Preliminary Drainage Report

Megerdichian Assisted Seniors Center (MASC) 8849 E CHOLLA ST, SCOTTSDALE, AZ 85260

25-ZN-2018

Plan # _____
Case # 25-ZN-2018, Cycle V2
Q-S # _____
 Accepted
 Correction
GA Reviewed By 10/26/020 Date

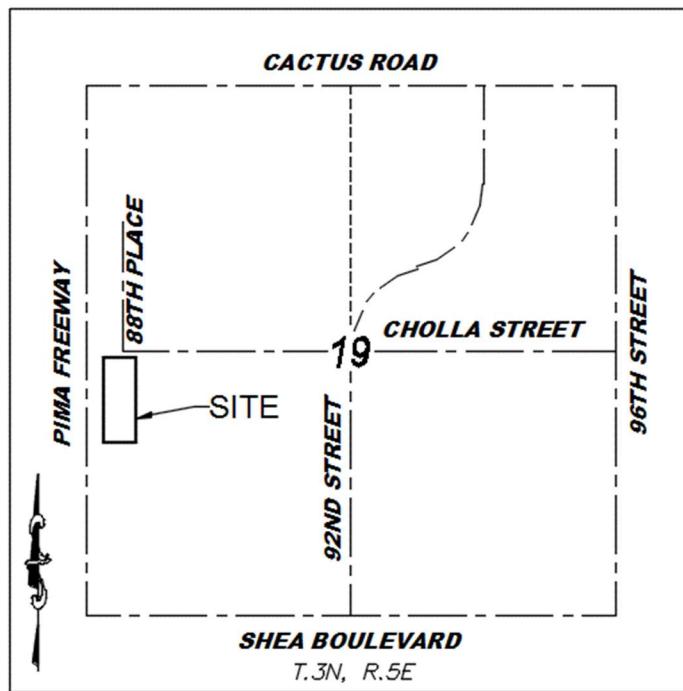
This referenced study is old. Update channel design flow, or justify it is still valid, or add a statement to indicate that the proposed improvement will not alter the corresponding channel and that the finished floor of proposed structures will be set to adequately protect the structures from any uncertainties of original channel design flow variation
